**REVIEW OF PROPOSED AA4 EXPANDITURE ON  
PICKTON-BUSSELTON 132KV LINE**

**ECONOMIC REGULATION AUTHORITY**

**Final**

**19 September 2018**

**Figure 1: Existing Network Configuration**

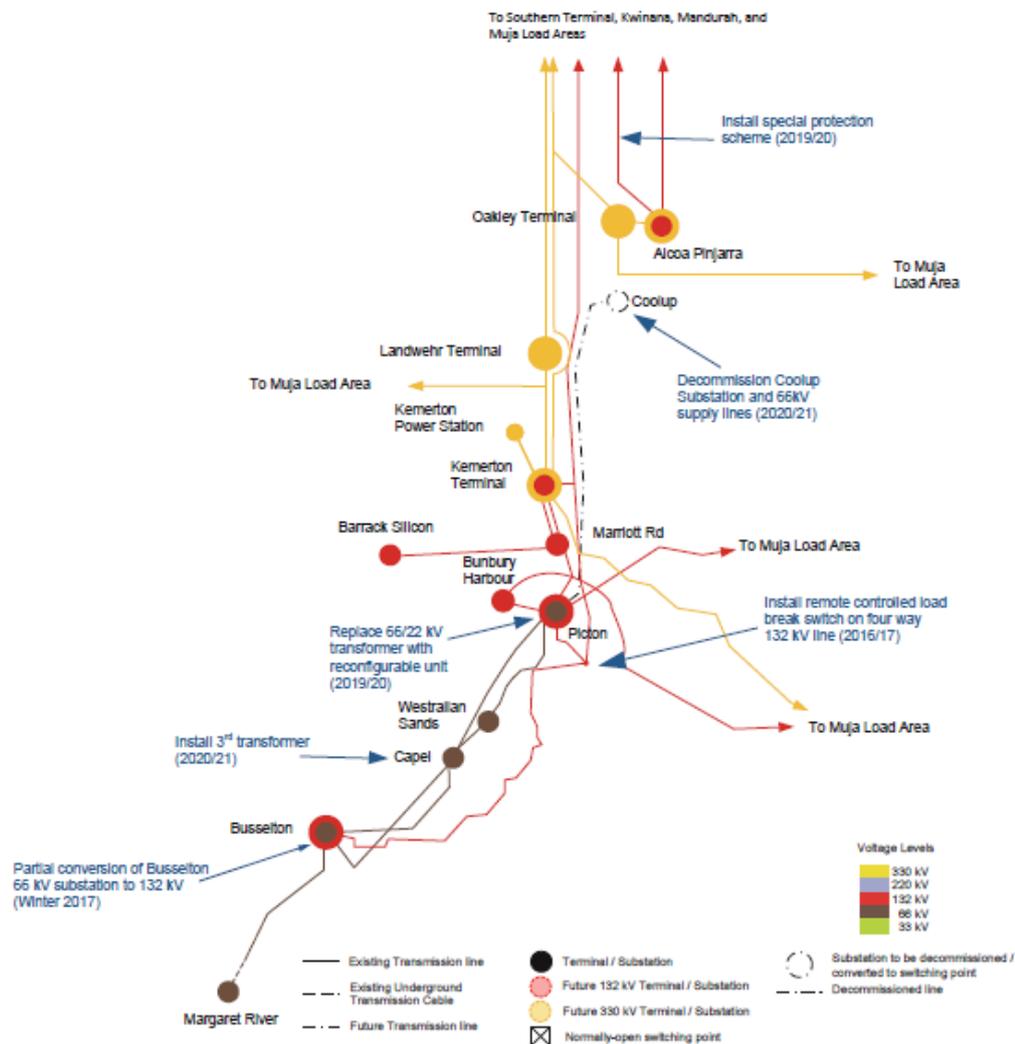
There are three incoming circuits feeding Busselton. The two older circuits operate at 66kV and supply Busselton from Picton, via Capel. One of the circuits between Picton and Capel supplies Westralian Sands which is a customer owned substation with a contracted

maximum demand of 13 MW. This demand is not forecast to change. The 132kV incoming circuit is a four-way circuit that terminates at Pinjarra, Kemerton, Picton and Busselton.

- The two 66kV circuits between Picton and Capel have a summer rating of 73 MVA and are both already constructed to be capable of 132 kV operation. This would double their power transfer capacity of each circuit to 146 MVA.

- The two lines between Capel and Busselton are rated at 53 MVA and 44 MVA. Approximately 70% of the 44 MVA circuit is constructed to 132 kV specification.

- The incoming 132 kV line is rated at 146 MVA. This line has a total length of 187 km and four terminations but is normally operated with the circuit breaker at Picton open. We have not examined the system load flows, but it appears that the main function of this line is to supply power from Kemerton, where there is a 330kV injection point and a 340 MW open cycle gas turbine power station, to Busselton and Pinjarra. WP has indicated that this line needs to be in service at times of peak demand to avoid overloads in the Pinjarra area.
